# City of Richmond

## Report to Committee Planning and Development Department

**File:** RZ 13-644887

**Re:** Application by Balandra Development Inc. for Rezoning at 8600 and 8620  
No. 2 Road from Single Detached (RS1/E) to Low Density Townhouses (RTL4)

**SITE PLAN**  
SCALE 1/8" = 1'-0"

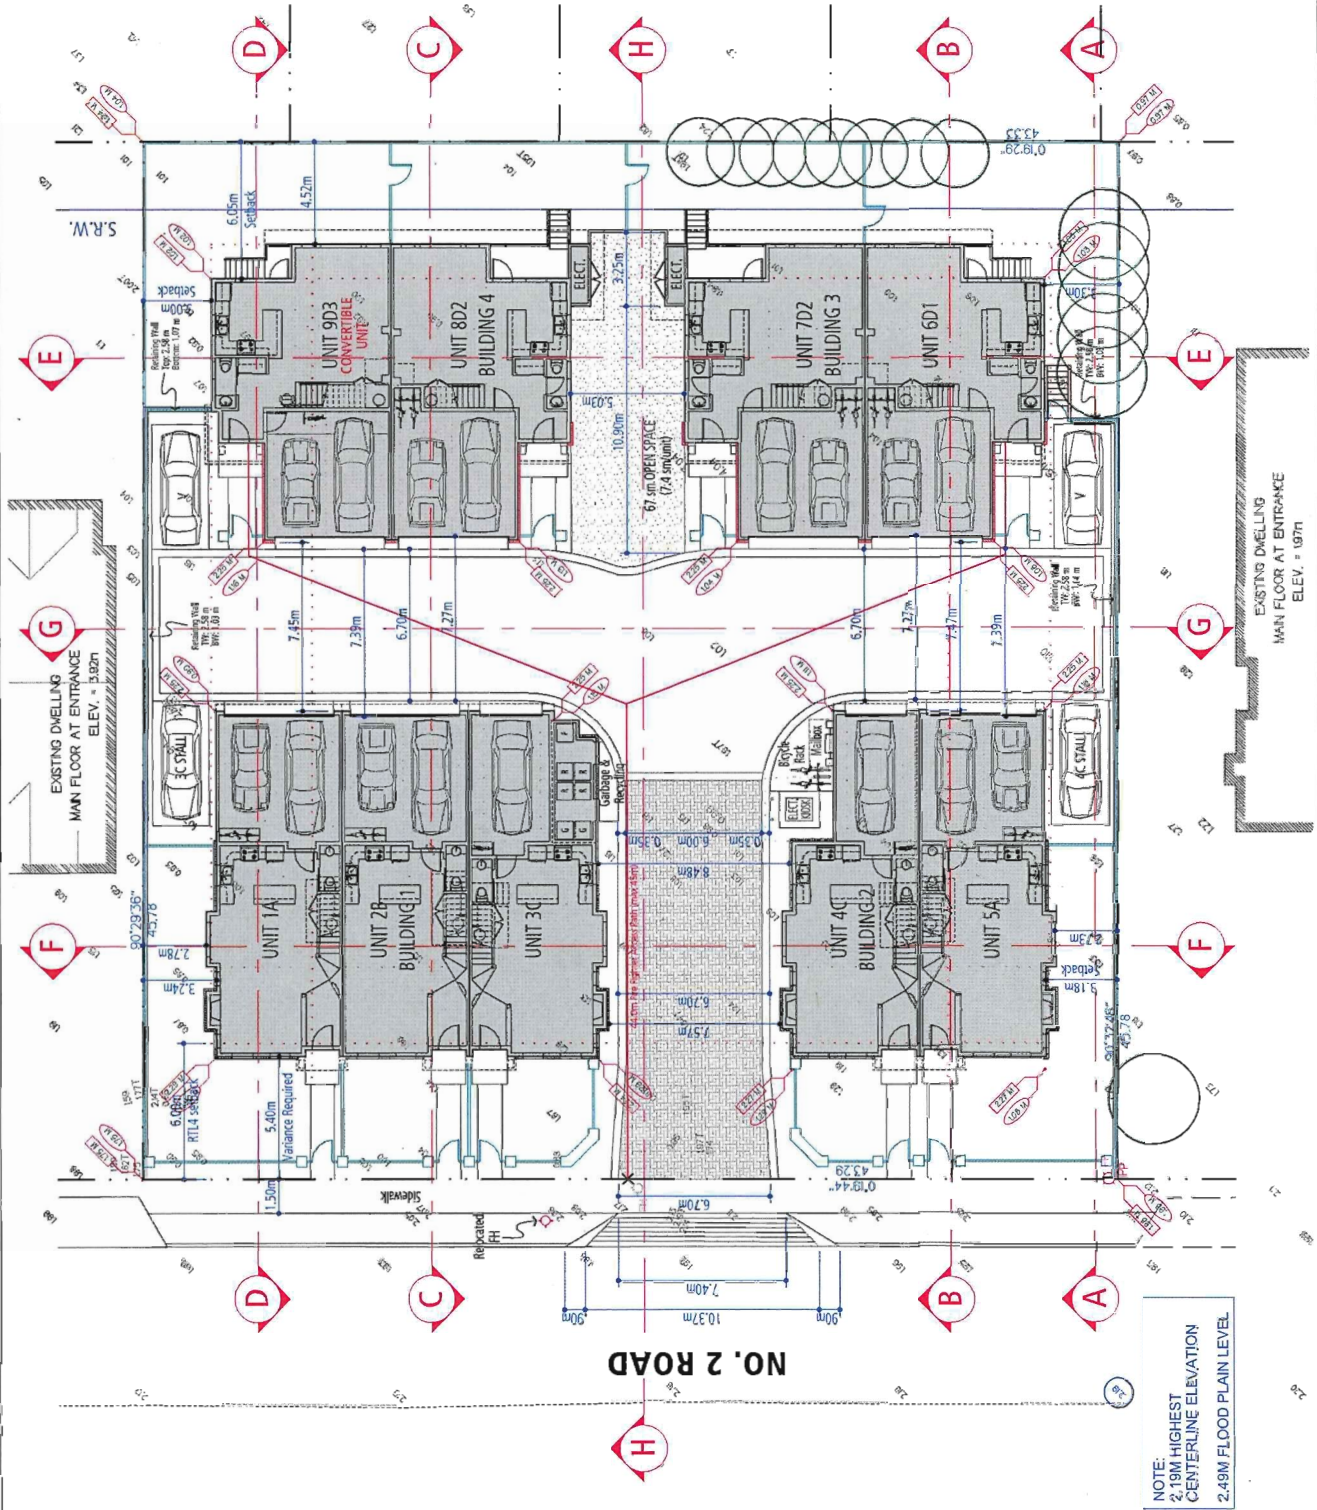
The proposed development is generally in compliance with the Low Density Townhouses (RTL4) zone. Based on the review of the current site plan for the project, the following variances are being requested:

1. Reduce the minimum lot width on major arterial road from 50.0 m to 43.29 m.  
*Staff support the proposed variances based on the discussion above in the OCP Compliance section.*
2. Reduce the front yard setback from 6.0 m to 5.4 m.  
*The Arterial Road Guidelines for Townhouses in the OCP support reduced front yard setback where a larger rear yard setback is deemed necessary, provided that there is an appropriate interface with neighbouring properties. The proposed rear yard setbacks at 4.5 m to ground floor and 6.0 m to the second floor exceed the zoning requirement of 3.0 m under the "Low Density Townhouses (RTL4)" zone. This variance will be*

3. Replace seven (7) standard residential parking stalls with small car stalls, one (1) in each of the side-by-side double car garages.

*Current Zoning Bylaw only allows small car parking stalls when more than 31 parking stalls are proposed on site. Transportation staff support the proposed variances to allow one (1) small car stall in each of the side-by-side double car garages.*

# SHADOW STUDY

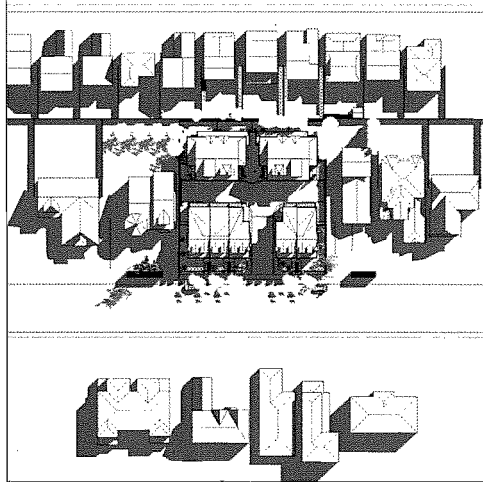
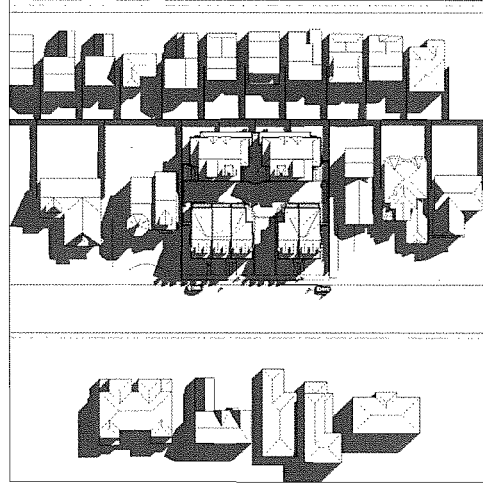
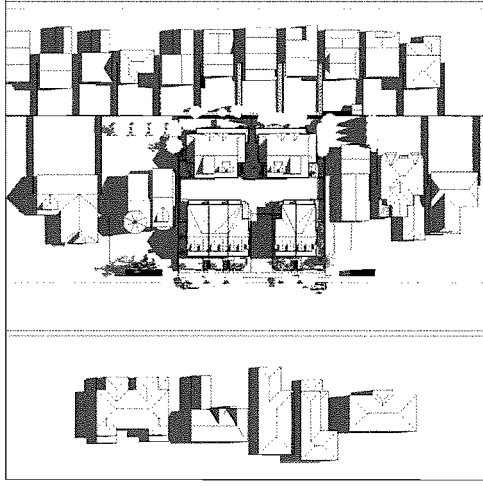
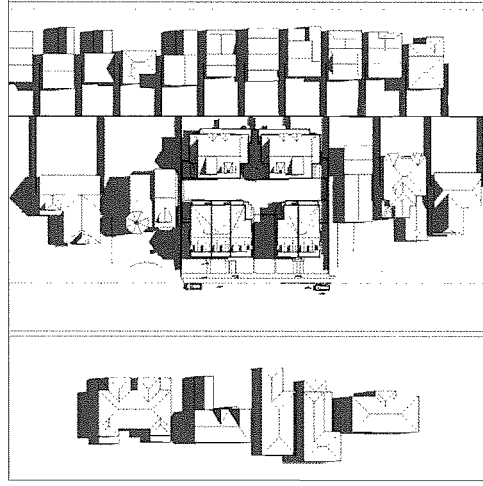
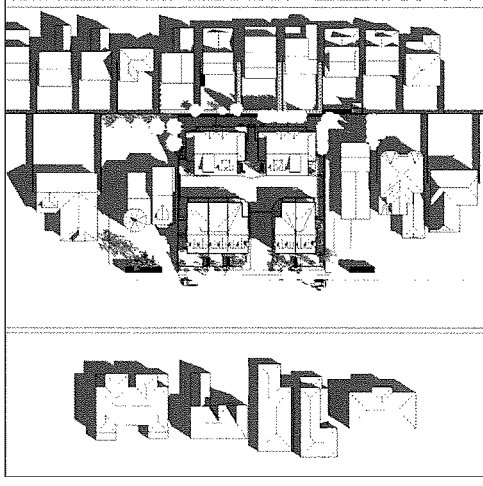
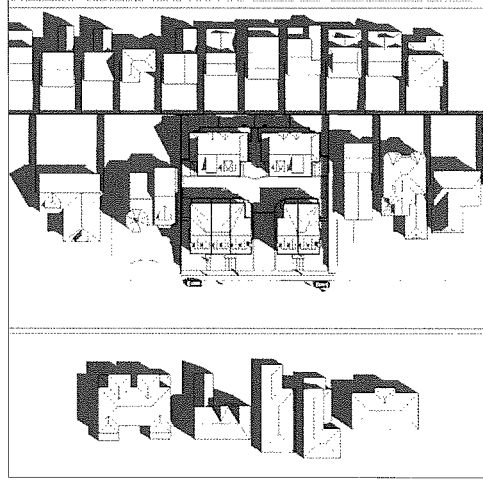
1. Loss of privacy and sunlight.

*A shadow study (Attachment 5) demonstrates that the proposed buildings will not cast any shadow over on the neighbouring back yards to the east.*
